RE: Advice on the “Response to Submissions” to Secondary Innovation Precinct (SSD-79146716)

Thank you for the opportunity to comment on the Response to Submissions (RtS) for State Significant Development (SSD-79146716) for Pymble Ladies Collage – Secondary Innovation Precinct at 20 Avon Road, Pymble.

Following a review of the revised documentation, Council maintains its **objection** to the proposed development. Council’s submission is contained in **Attachment 1**.

Figure 1: Extract from RTS Appendix C – Architectural RTS response

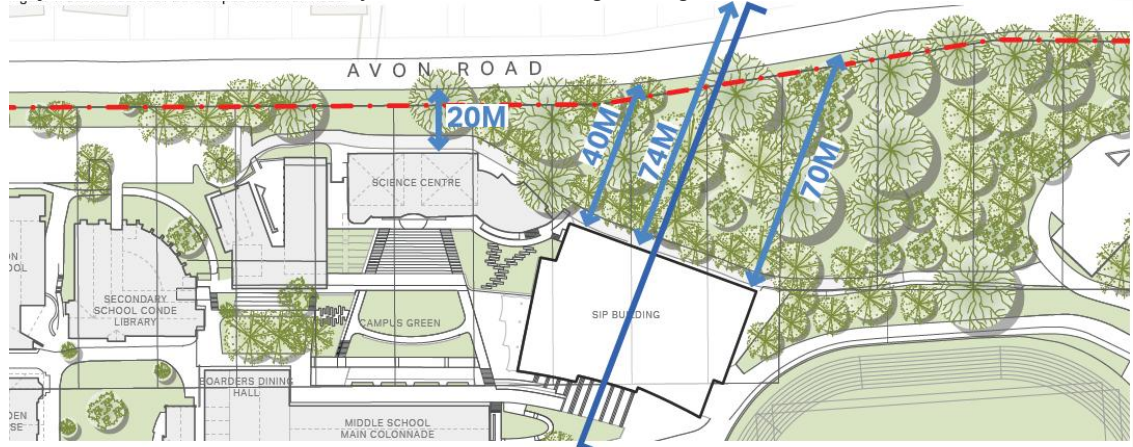
The western front corner of the proposed SIP building is setback 40 metres from the north-western boundary (Avon Road frontage), which is consistent with the setback of the north-eastern front corner of the existing Science Building (refer to Figure 1). The Science Building adjacent to the proposed SIP building is highly visible from Avon Road (refer to Figure 2). While trees within the proposed 'Lower Riparian Zone' are to be retained, the visual impact of the proposed development should not rely on vegetation for screening. As such, concerns remain regarding the lack of articulation or modulation to reduce its visual bulk on the northern façade of the six-storey building, which fronts Avon Road and adjacent R2-zoned low density residential dwellings along Avon Road.
